Appendix I of RNTPC 1A 9 A Paper No. A/YL-ST/640B 步到。城市想想委员会 待才正司 申题的目档。 Form No. S16-III 9 JAN 2023 表格第 S16-III 號 This discontaining Factor will formally acknowledge The Term Planning Factor will formally acknowledge the date of receipt of the application only upon receipt of all the required information and documents. **UNDER SECTION 16 OF** THE TOWN PLANNING ORDINANCE (CAP.131) 根 據 《城市規劃條例》(第131章) 第16條遞交的許可 申

This application is to seek planning permission from the Town Planning Board ("**TPB**") to extend the previously approval for the temporary cold storage development (**TPB/A/YL-ST/573** on 10 July 2020) for a period of 3 years at Lots No. 16 S.B ss2(part), 16S.B ss3(part), 19RP, 19SC, 21RP(part), 21SA(part), 23SA, 24RP(part), 25SA(part), 26RP(part), 42RP(part) and 44SA(part) in D.D. 105 and their adjoining Government land, south of Castle Peak Road – San Tin Section, Mai Po Lung, San Tin, Yuen Long.

We would like to submit herewith Responses to Comments from Drainage Services Department, Environmental Protection Department and Agriculture, Fisheries and Conservation Department for the consideration of the Town Planning Board. In addition, the previous Fire Service Instal

Appendix B3 Proposed Drainage System of Application Site

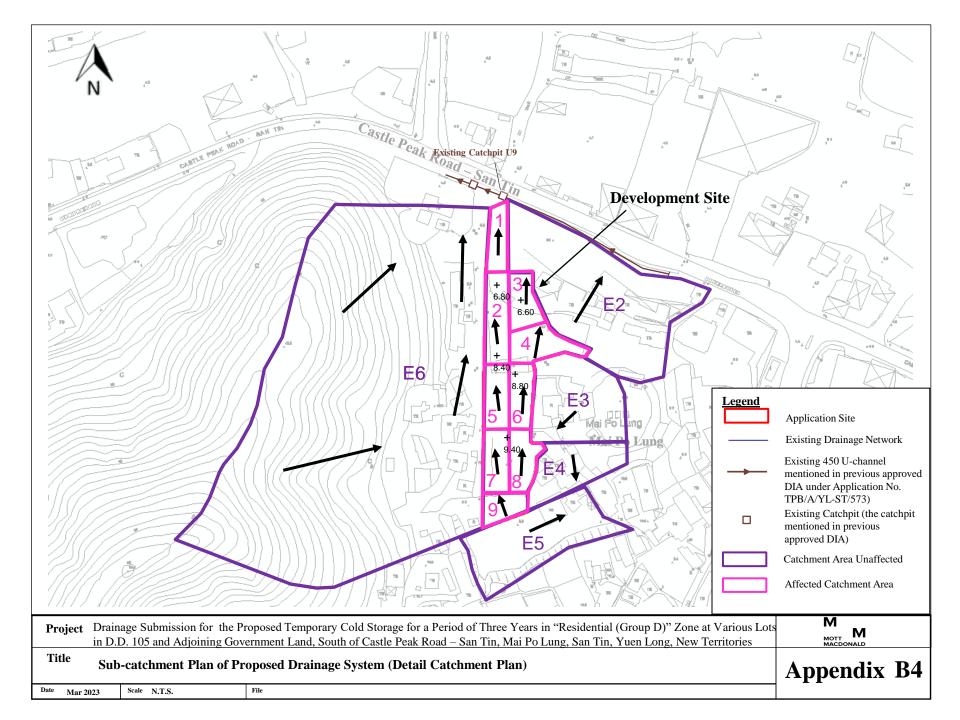
Item Reference	Comment	Response		
1.8	At the south of the proposed building, part of the peripheral of the application site is not intercepted with drainage system. Please advise.	Peripheral channels have been provided at the application site boundary for intercepting runoff. The layout plan of proposed drainage system is shown in the Appendix B3 in the Rev A.

Figure 1 - Silted existing 450 u-channel observed during site visit

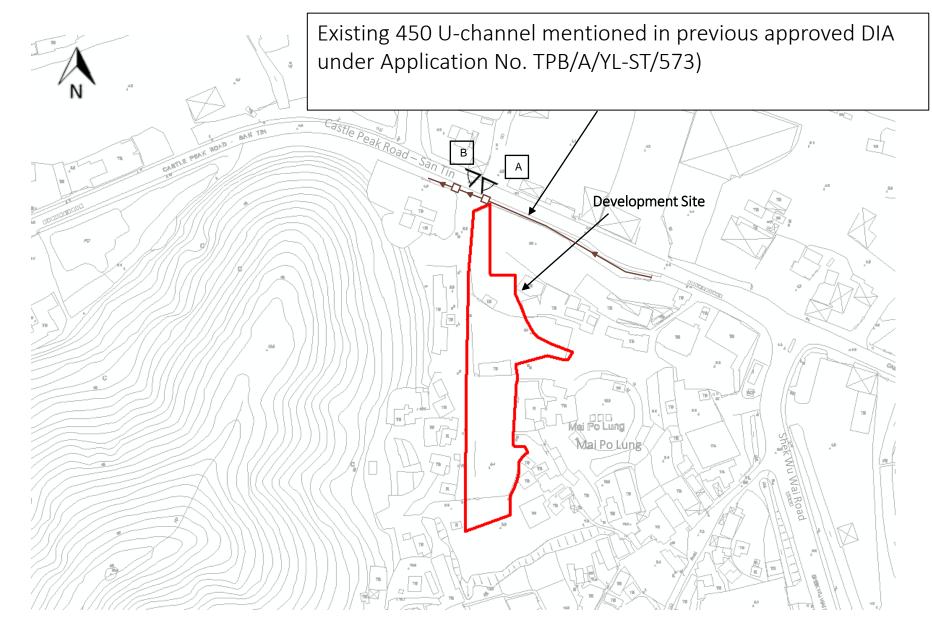
1.5	Please provide the record of the existing condition of the 450 U channel at the downstream of the application site for our review. As mentioned in the proposal a catchpit U9 is formed, please advise whether it is an existing manhole or a proposed new manhole by applicant.	The existing 450U channel (Figure 1 attached) and relevant site photos are in Appendix C in the Rev A. The catchpit U9 in previous submitted drainage proposal is an existing catchpit.

Plan 1: E&M Layout

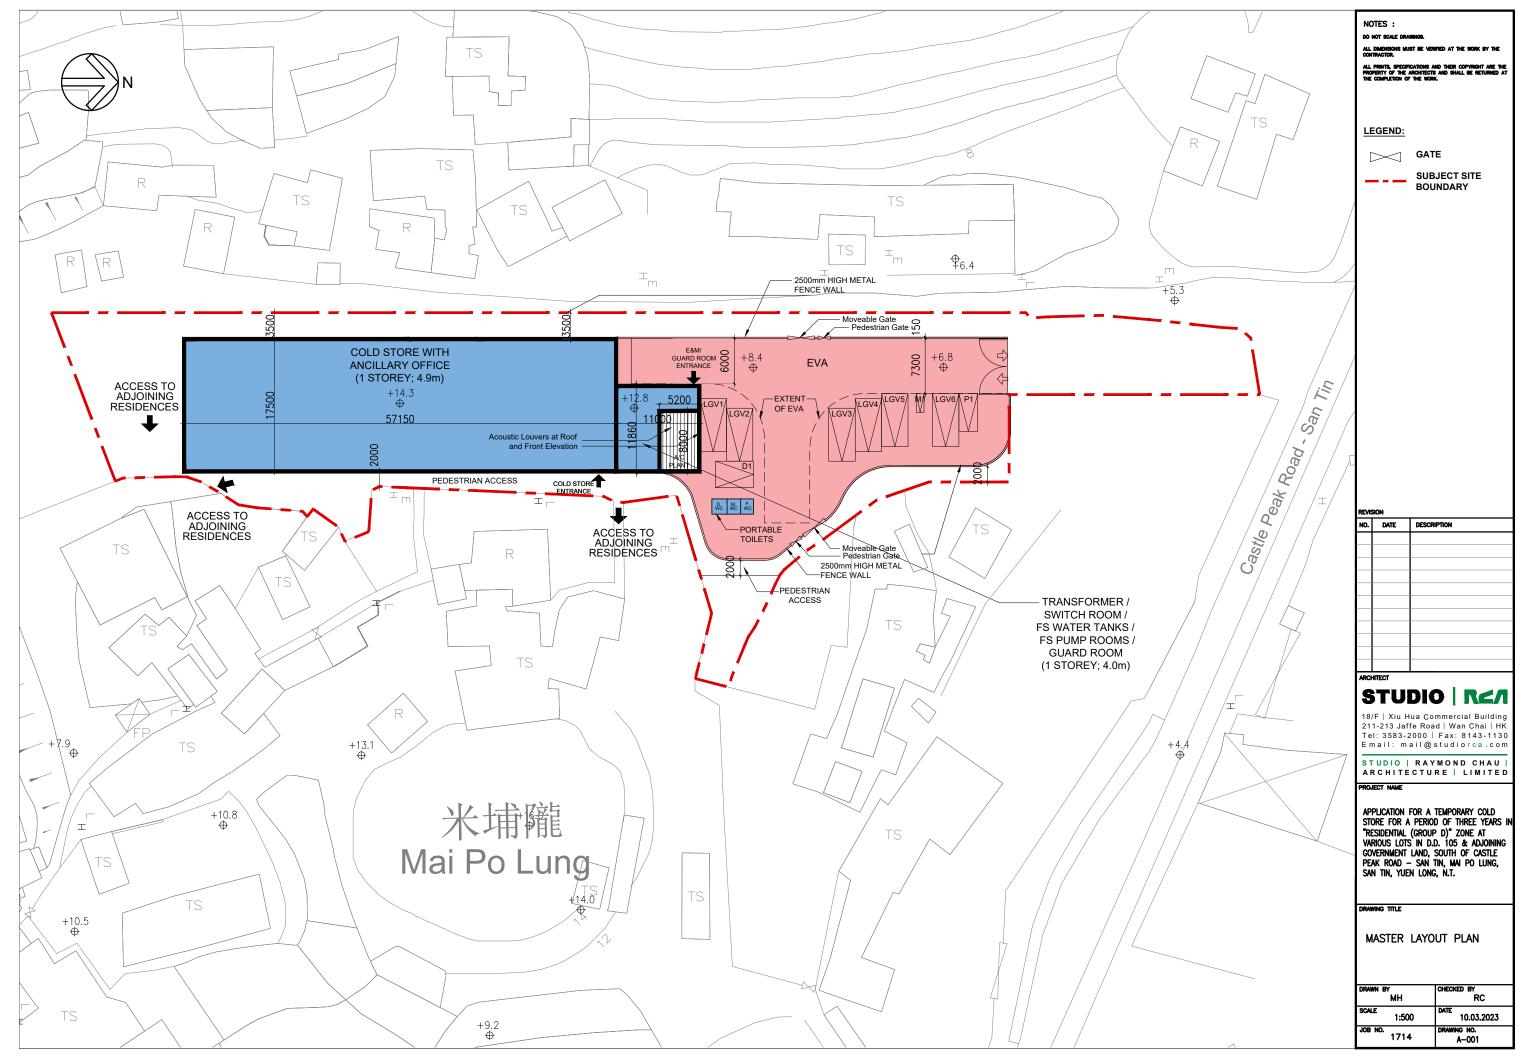
3	Comments from EPD : Ms. CHAN Lai Mei, Jolitta T: 2835 1112	via DPO email 9.2.2023		
	The applicant is requested to provide a layout plan to clarify whether the E&M machinery would be fully enclosed within the cold store building and the openings such as windows/doors of the building will be directed away from nearby sensitive receivers to avoid adverse noise impact on nearby sensitive receivers.	The layout plan for the fully enclosed arrangement of the E&M room is attached (Plan 1) for reference.
